GFA AIRWORTHINESS DIRECTIVE

SUBJECT: Elevator mass balance.

SUBJECT: Horizontal tailplane – elevator mass balance

WORKING INSTRUCTIONS FOR INSTALLING ELEVATOR MASS BALANCE

SCALE 1:1

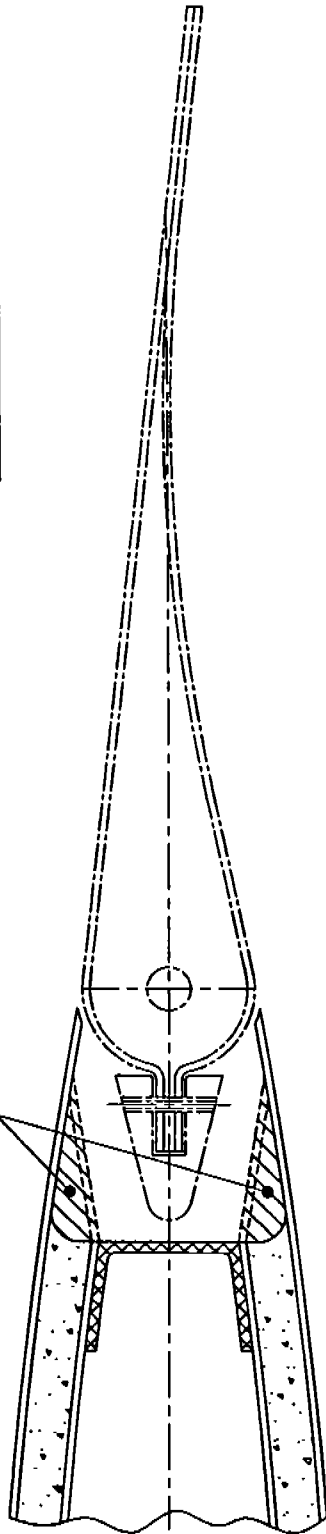
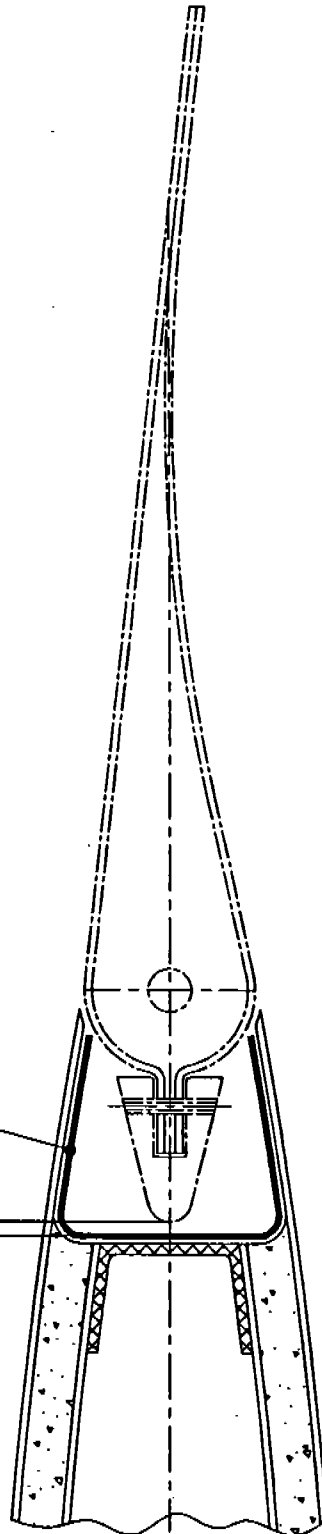
1. Remove elevator halves.
2. Stabilizer
 - a) Remove glass cloth and foam core from shroud up to the web
- see also page 02 and 03.
 - b) Reinforce shroud and web by applying additional carbon/glass cloth layers – see page 03.

3. Mass balance
 - a) Fit mass balance weight to elevator halves; make sure that there is a clearance of at least 2 mm between lead and web – see page 02 and 03.
If necessary, shorten elevator joining flange ahead of the hinge.

glass cloth and foam
to be removed

reinforcement
1xCF200g/m² ✕ +1x92110✕

clearance at least 2 mm

mass balance
(~0.5 kg lead)

roll pin Ø2x14 (DIN 1481) - grind flush
